STATE OF ILLINOIS
DEPARTMENT OF NUCLEAR SAFETY

RADIOACTIVE MATERIAL LICENSE
IL-01013-01

The Illinois Department of Nuclear Safety has received your letter dated April 27, 1995, requesting an additional jobsite. The preliminary review of your request is complete, the following additional information is necessary:

Re: Response to your letter dated June 1, 1995 regarding our Radioactive Materials License IL-01013-01 Pending Amendment

#48, 50 & 51 show
S.A. Huber Consultants, Inc area

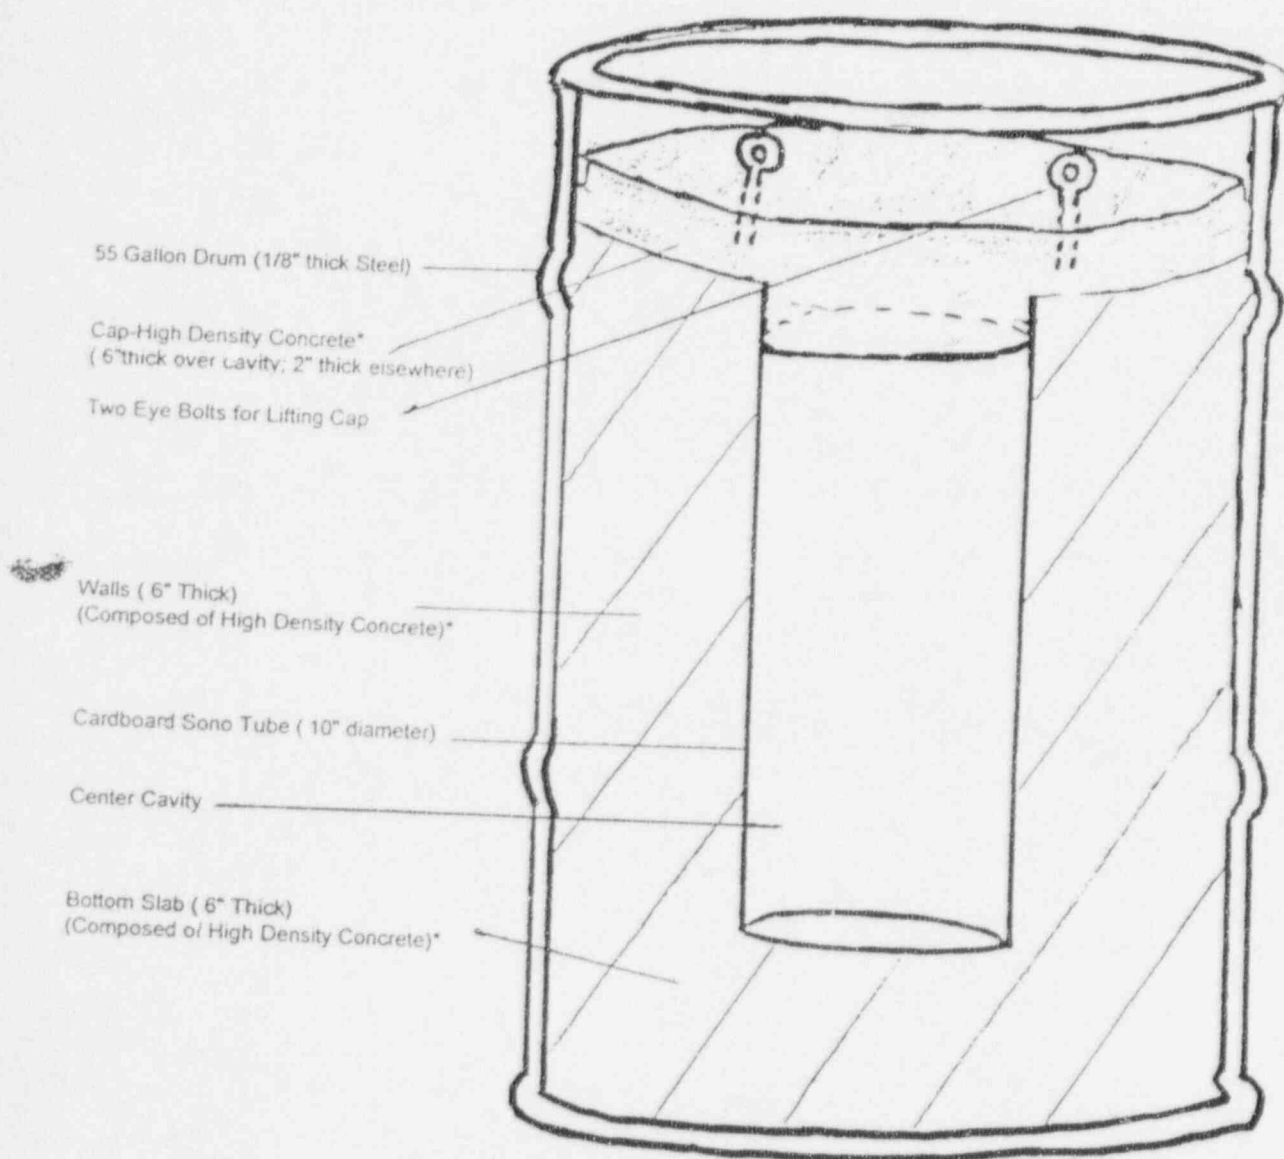
17. Please specifically identify use and storage areas on your facility diagram to include receipt and storage areas, production areas, waste storage areas, etc.

17. See attachment No. II (The area our firm will occupy is highlighted. These areas are marked #48, 50 and 51.)
18. The facility is still under construction, but our part of the building is located along outside walls and has inner walls being built to separate it from the rest of the building. There will be at least a 200 CFM exhaust fan installed to assure negative pressure. There are no direct air supply vents to the area. The proof of negative air pressure will be submitted to the IDNS prior to container construction. Our ventilation system will be checked on a semi-annual basis.
